**Historic Review**  
**Staff Report for a Single Family Home in the Canemah Historic District**  
**August 21, 2018**

**FILE NO.:** HR 18-09: Historic Review Board review of construction of a new single family residence in the Canemah National Historic District.

**REQUEST:** Construction of a new single family dwelling in the Canemah Historic District.

Front elevation

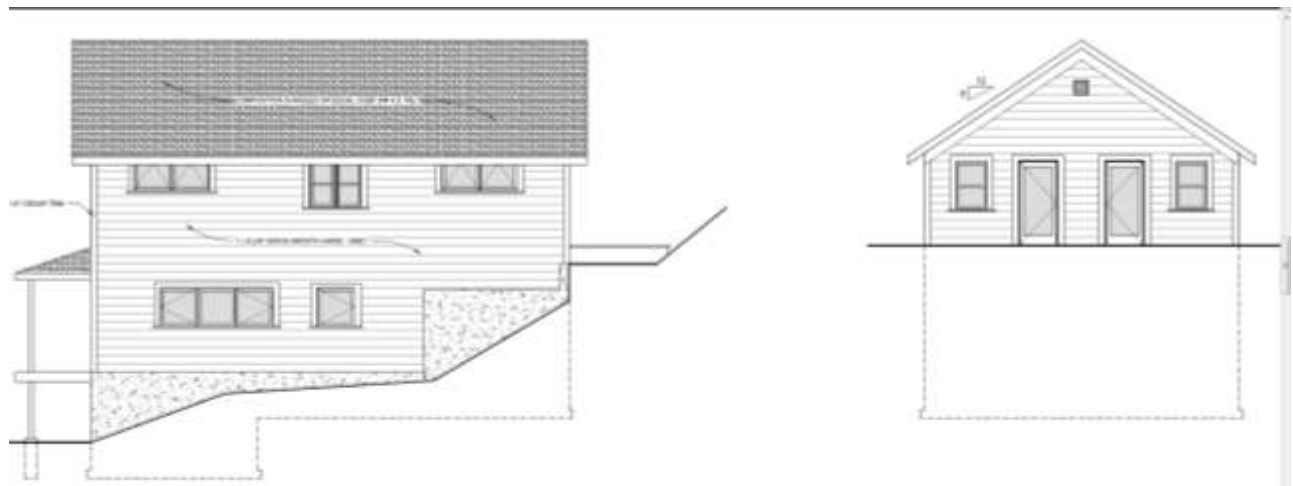
The home has a full width hip roofed porch to help break down the overall scale of the building. The porch columns are simple untapered design. If the applicant is including a porch rail, the railing shall have fewest number of balusters as possible to meet building code, and porch posts shall be incorporated into the rail. Also, top and bottom perpendicular railings are required.

The applicant did not propose a stair leading to the front porch, and the perspective drawing submitted shows the first floor of the home at the same elevation as the garage floor. However, the original home utilized a stair and it is possible that after geologic hazard conditions are considered, the design may require a stair. The applicant shall be required to come back to the Historic Review Board for a modification if the access to the front porch/front door requires a stair.

For the latticework under the front porch, the applicant shall use 90 degree perpendicular wood lattice or other architectural styles appropriate for house, painted either to match the color of the house or to blend in with the surroundings.

The exterior is proposed to be covered with 8" smooth fiber cement lap siding, with simple 6" corner and window trim and 12" verge trim at the gable ends. Exterior decoration is simple, no architectural detailing is proposed. The windows on the front façade are 1:1 and double hung. The front door is shown as half-lite. The side elevations include casement windows and paired windows. While these are not typical of the vernacular style, the limited use of such windows has been deemed compatible.

The applicant proposes vinyl windows. The applicant shall use wood or fiberglass (Marvin Integrity or equivalent) windows. If fiber cement siding is used, smooth boards are required. The window sash shall be the darkest color of the three color paint scheme. The applicant shall also utilize simple vernacular styled exterior lighting.

5. If the applicant is including a porch rail:
  - a. the railing shall have fewest number of balusters as possible to meet building code
  - b. porch posts shall be incorporated into the rail

- c. top and bottom perpendicular railings are required
6. For the latticework under the front porch, the applicant shall use 90 degree perpendicular wood lattice or other architectural styles appropriate for house, painted either to match the color of the house or to blend in with the surroundings.

7. Exposed lattice plus any siding/boards proposed under the front porch shall not be more than 6 feet in height. (P)
8. The applicant shall be required to come back to the Historic Review Board for a modification if the access to the front porch/front door requires a stair. (P)

4. The applicant shall utilize the following:
  - a. Wood or fiberglass windows and doors. Fiberglass windows (Marvin Integrity or equivalent)(P)
  - b. If fiber cement siding is used, smooth boards are required. (P)

- c. Full or half-lite exterior doors or other appropriate for Vernacular style. (P)
  - d. The window sash shall be the darkest color of the three color paint scheme.(P)

West and south elevation

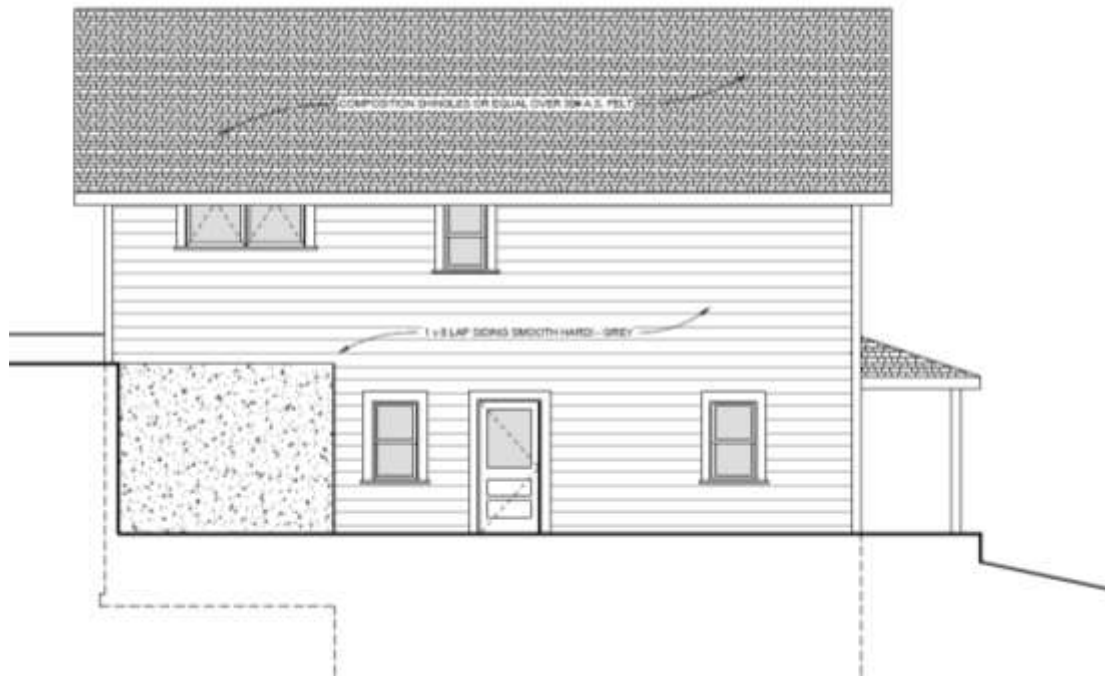
The width of the home is 25 feet. Height measured to the eave is 17 feet from the ground floor. When measured from grade, the height is 23 feet to the eave, which is closer to the maximum 1:1 ratio. When height is measured to the midpoint of the peak and eave of the roof, the height is 22 feet and 28 feet, respectively. The house is fairly wide for a Vernacular style, however, the narrow windows mitigate for the width.

The massing will appear large due to the slope of the property. The plans show an additional six feet in height of mass underneath the front porch. Exposed lattice plus any siding/boards proposed under the front porch shall not be more than 6 feet in height. Landscaping shall also be utilized to visually shield the massing. The property has significant vegetation already, but much of it is invasive plants. After clearing of invasive plants and before a certificate of occupancy is issued, staff will work with the applicant to determine if additional plantings are needed to provide screening. A maximum of ten shrubs and four trees may be required.

The rear elevation includes 1 over 1 windows and two full lite doors. Both full and half-lite doors are acceptable in all locations. Doors shall be wood or fiberglass. Minor changes to window location on the side and rear facades will be acceptable and may be approved at a staff level prior to building permit issuance.

3. The applicant shall obtain all necessary permits for work in the Natural Resource Overlay District.
4. Minor changes to window location on the side and rear facades will be acceptable and may be approved at a staff level prior to building permit issuance.

3. Landscaping shall also be utilized to visually shield the massing under the porch and on side elevations. After clearing of invasive plants and before a certificate of occupancy is issued, staff will work with the applicant to determine if additional plantings are needed to provide screening. A maximum of ten shrubs and four trees may be required. (P)
